# EAST MARICOPA FLOODWAY CHANDLER HEIGHTS BASIN RITTENHOUSE BASIN FAILURE MODE AND CONSEQUENCE ANALYSIS REPORT

**JANUARY 2002**

PEER REVIEWED BY  
J. LAWRENCE VON THUN  
CIVIL ENGINEERING CONSULTANT

**VELOCITY CURVES FOR PIPING, EROSION, AND DEPOSITION OF SOILS**

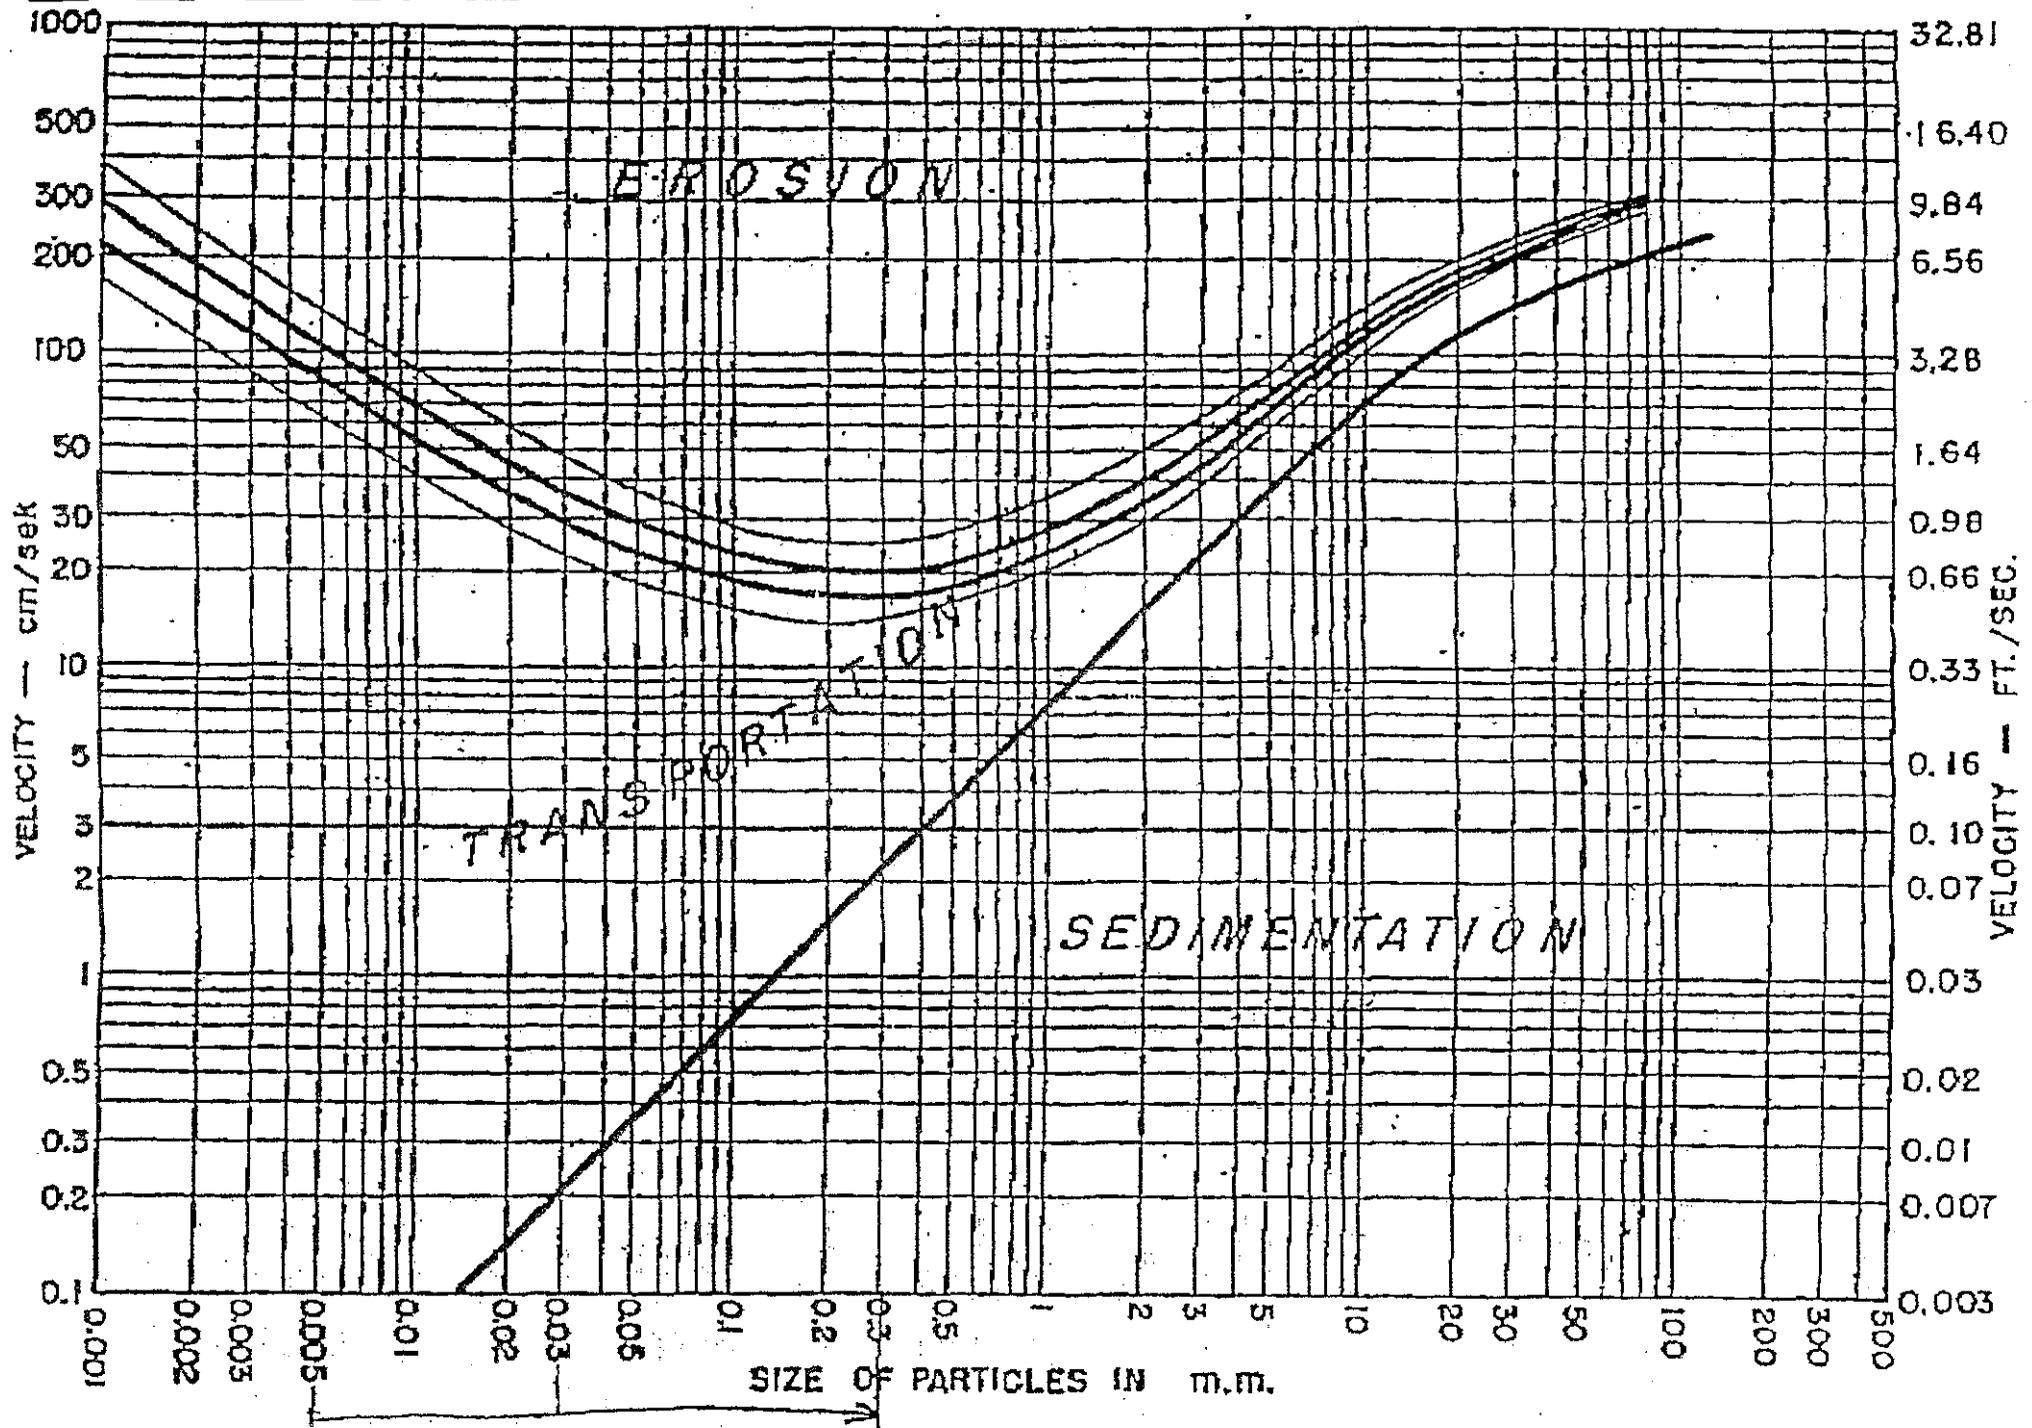
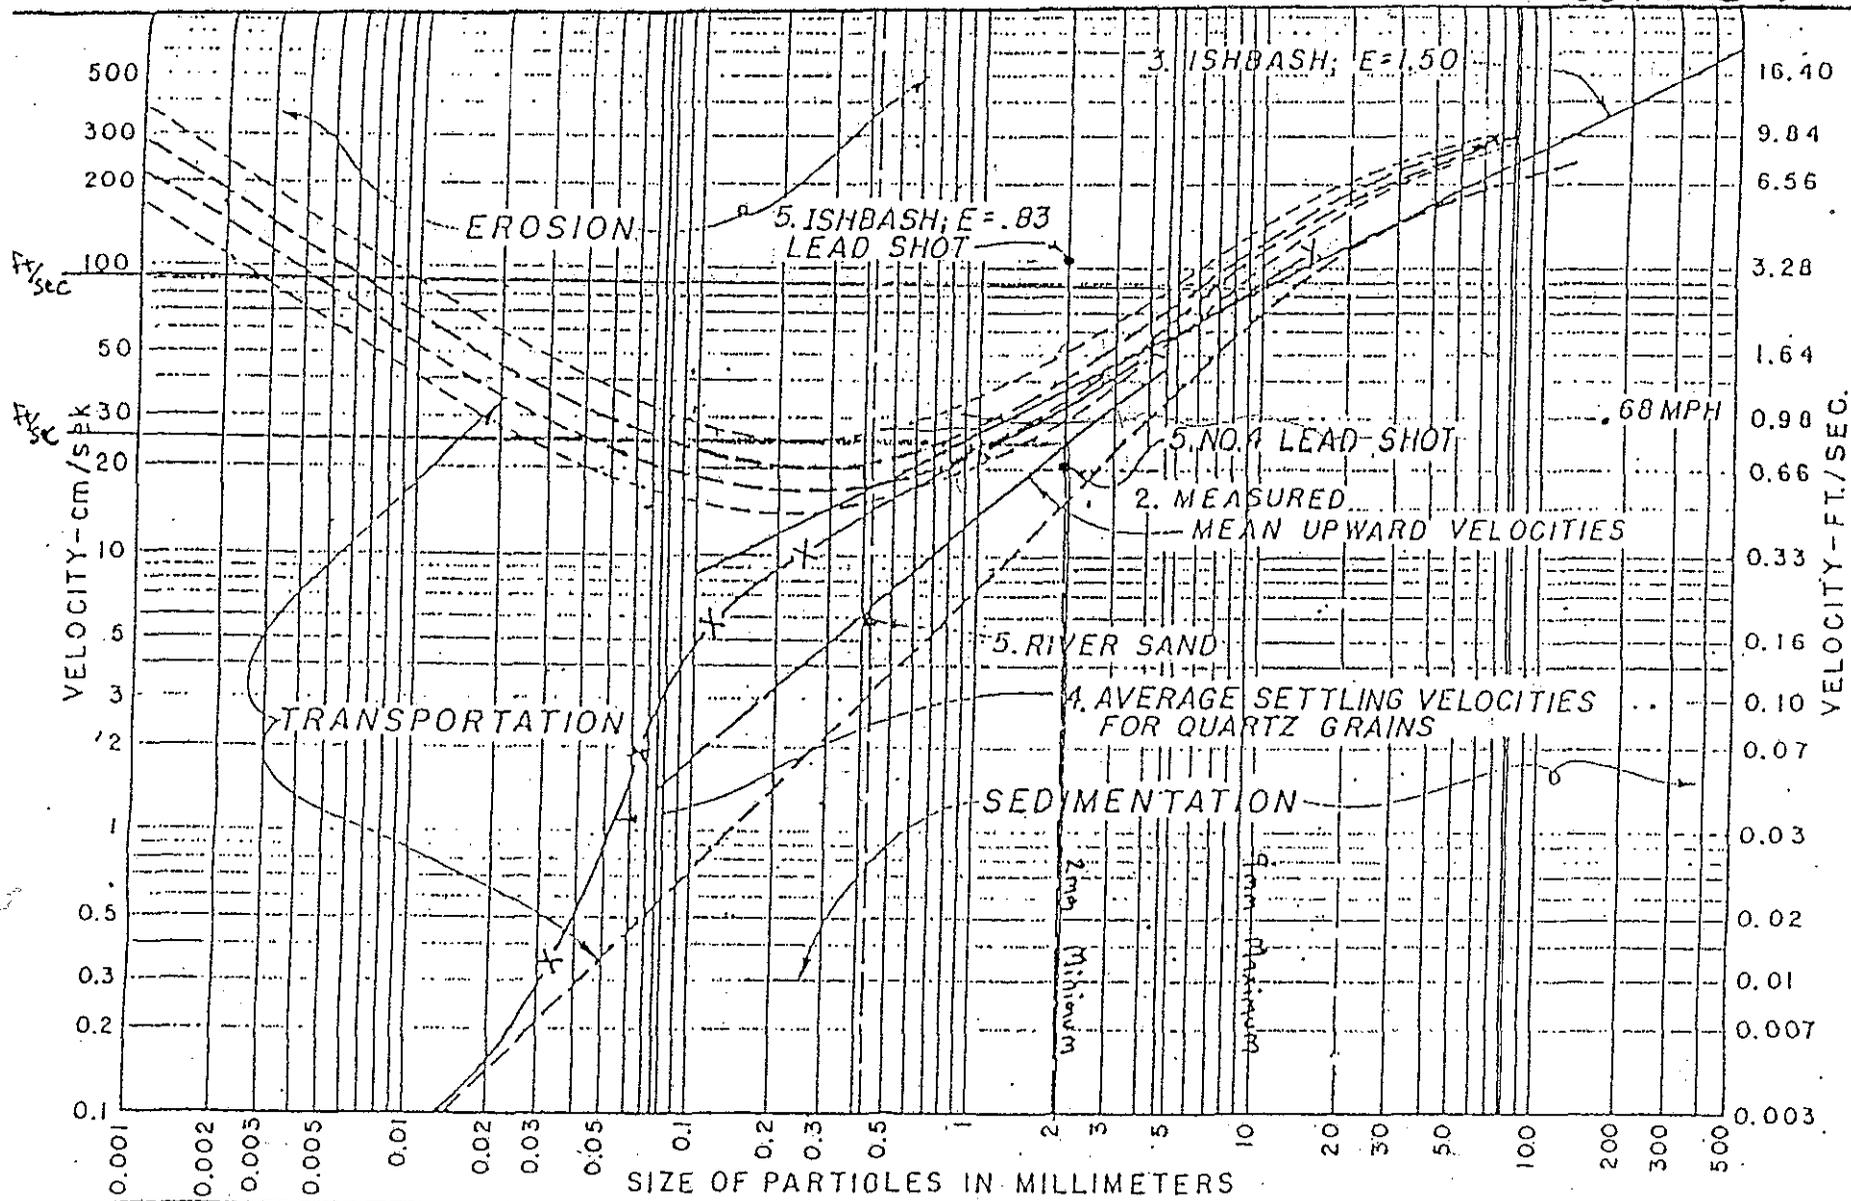
- This is a decelerating process generally but could be accelerating if the inflow source is relatively unrestricted (e.g. gravel layer is very wide at inlet and narrows through levee.
- Flooding events are very infrequent
- Both the EMF and the basins will have low hydraulic gradients on the order of 5-10 feet
- Breach flow release is probably small, which will allow time for people to escape since the basins are so large
- The gravel layers are probably above the basin bottom at RB
- Flow velocities would generally not be expected to be high enough to be erosive (see the sedimentation / erosion / deposition chart in the Appendix)
